TECHNICAL EVALUATION REPORT

Decommissioning of the West Valley Demonstration Project (WVDP) is conducted under the 1980 West Valley Demonstration Project Act (WVDP Act). The WVDP Act requires the U.S. Department of Energy (DOE) to decontaminate and decommission, in accordance with any requirements prescribed by the U.S. Nuclear Regulatory Commission (NRC), the waste storage tanks and facilities used in the solidification of high-level radioactive waste, along with material and hardware used in connection with the WVDP. The NRC responsibilities under the WVDP Act include the prescription of decommissioning criteria, informal review and comment, and monitoring.

This Technical Evaluation Report (TER) documents NRC staff's comments on the Phase 1 DP for WVDP. The TER also includes NRC's determination of whether the proposed action in the Phase 1 DP satisfies the decommissioning criteria. As such, NRC's review of the Phase 1 DP focuses on information relevant to assessing whether the decommissioning criteria have been met (such as, planned decommissioning activities, radiological status of facilities, dose modeling, and final status surveys). In this review, NRC specifically evaluated

Figure 1 Site Map Showing Areas to Be Remediated in Phase 1

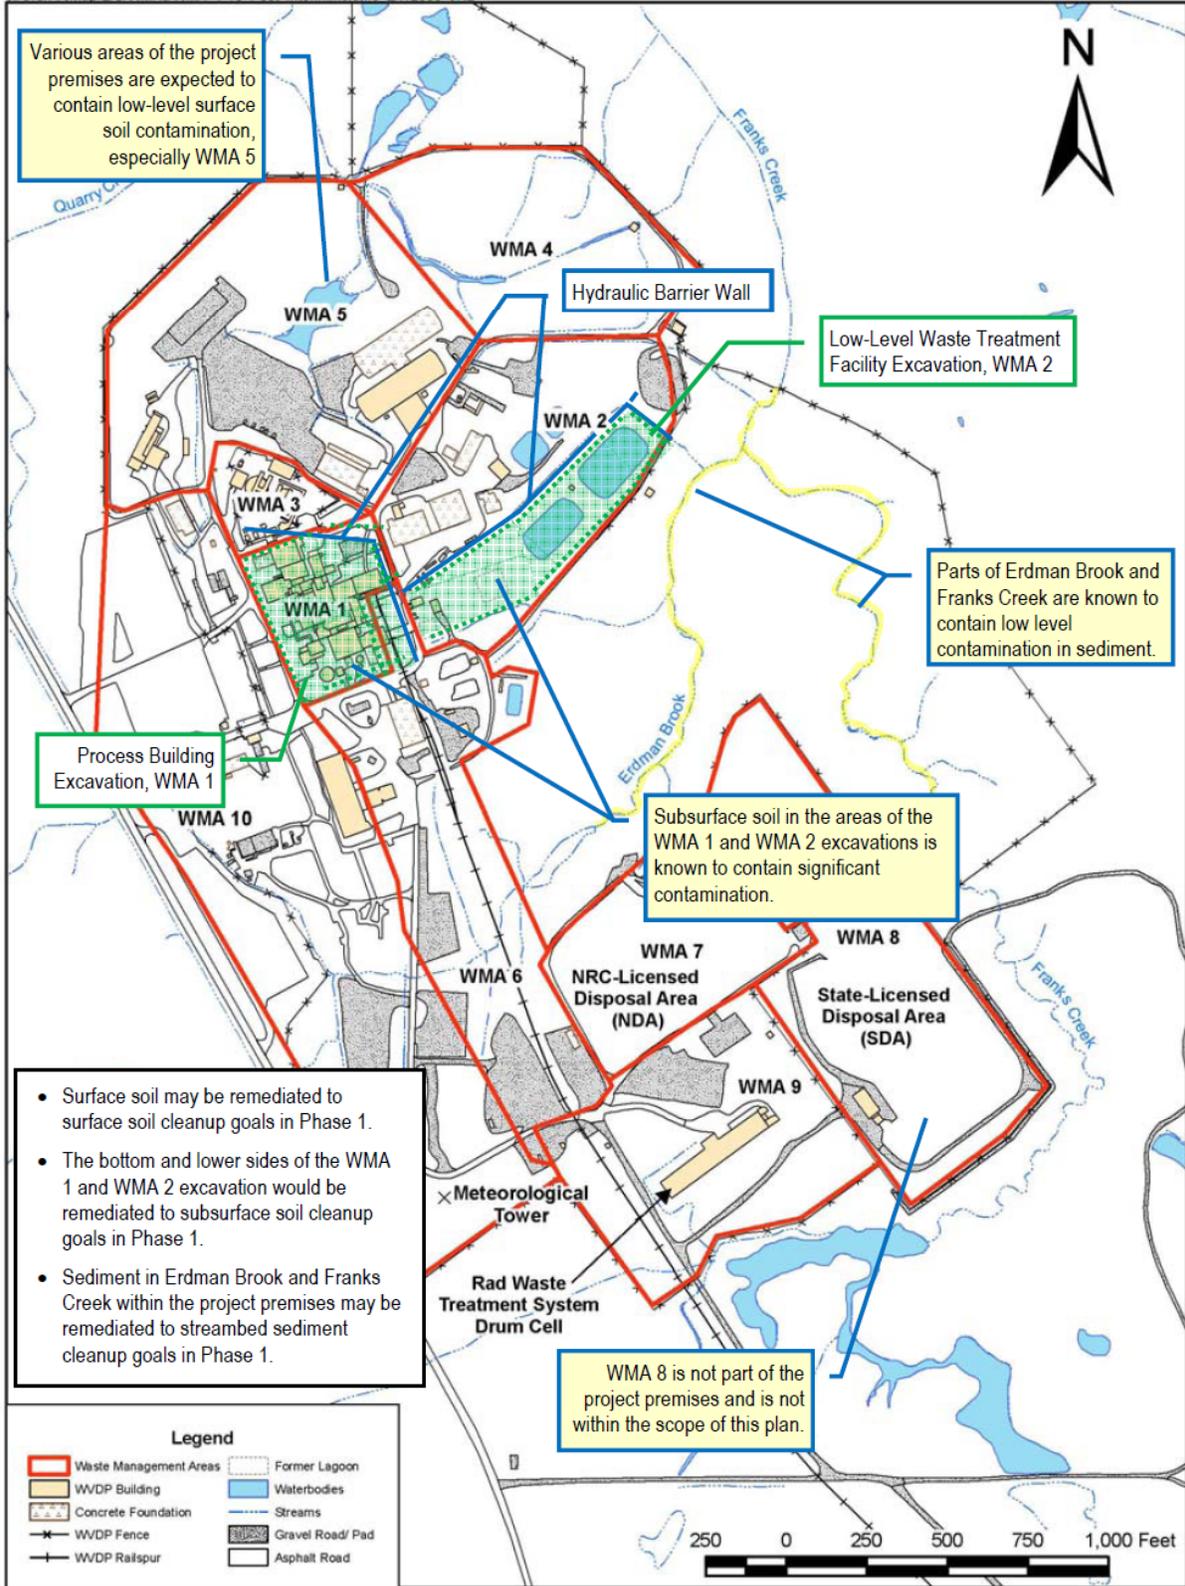
Comment: If previously cleaned areas become re-contaminated, the collection of additional information during the ongoing assessment period reveals that risks are significantly underestimated, or modeling assumptions otherwise become invalid, NRC expects that the impact of these events on the ability of the site to meet LTR criteria will need to be re-evaluated at the time of final decommissioning.

Figure 8 - DOE's Proposed Use of Permanent Engineered Barriers for Phase 1 Decommissioning Activities and Associated Monitoring Locations

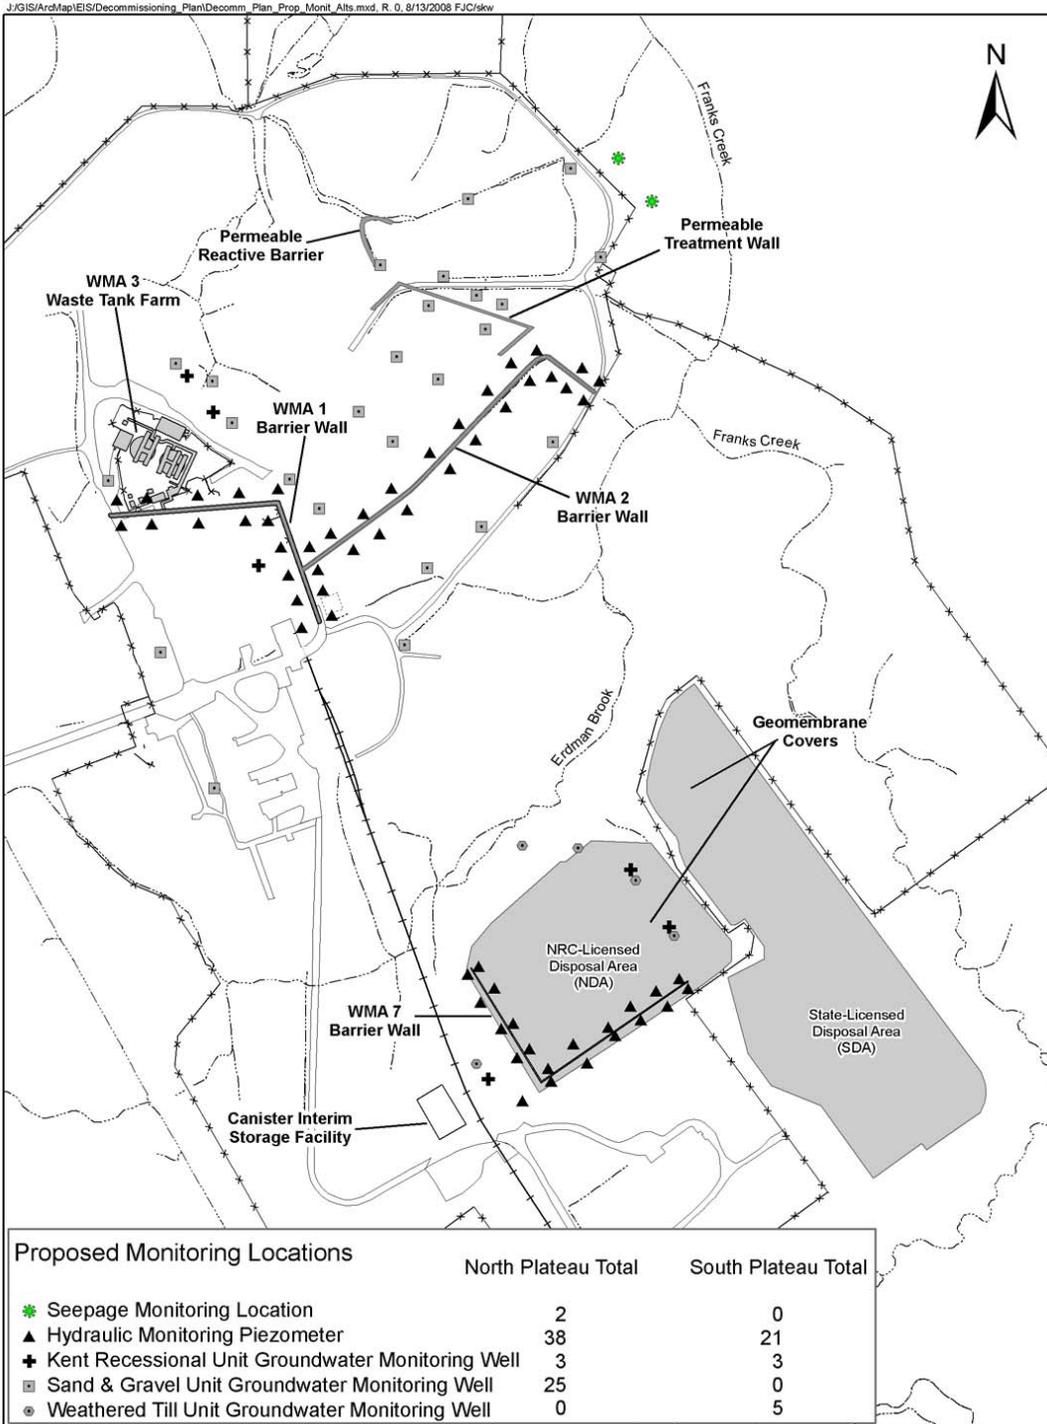
Comment: Potential adverse impacts of final engineered barrier designs have not been evaluated at this time. DOE needs to evaluate any potential adverse impacts of final engineered barrier designs that may affect risk calculations to support Phase 2 decision-making.
